Product Discontinuation Notices

No. OEE-2022309

Discontinuation Notice of Round Connectors Model Y92E-S__PVC series.

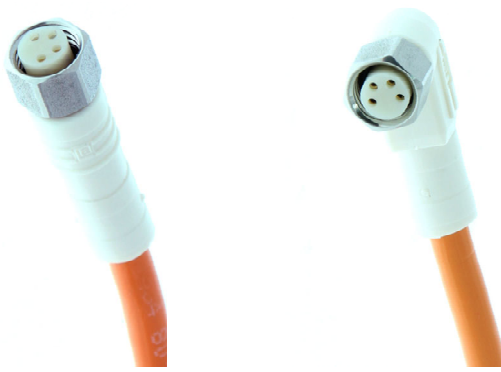
[Difference from discontinued product]

Recommended replacement Model	Body Color	Specifications	Materials	Dimensions
Model Y92E-S _{xx} PP series	*	**	*	**

Product discontinuation Model Y92E-S__PVC series	Recommendable replacement Model Y92E-S__PP series
<p>M12 models</p> 	<p>M12 models</p> 
<p>M8 models</p> 	<p>M8 models</p>

Product discontinuation Model Y92E-S_PVC series	Recommendable replacement Model Y92E-S_PP series
<p>M12 models</p> <p>M8 models</p>	<p>M12 models</p> <p>M8 models</p>

Model	Product discontinuation Model Y92E-S__PVC series	Recommendable replacement Model Y92E-S__PP series
Rated current 4 A	4 A	4 A
Rated voltage	M8: 30 VDC M12 4-wire: 250 VDC	M8: 60 VDC M12 4-wire: 250 VDC
Degree of protection	IP67, IP69K	IP67, IP68, IP69K
Ambient Temperature	-25°C to +70°C	-30°C to +90°C

Model	Product discontinuation Model Y92E-S_PVC series	Recommendable replacement Model Y92E-S_PP series
Pin block	PVC	PP (Polypropylene)
Contacts	CuSn, nickel base, 0.3 µm gold plating	Cu/Au, 0.3 µm gold plating
Fixture	Stainless steel	Stainless steel
Cover	PVC	PP (Polypropylene)
O-ring	EPDM	EPDM
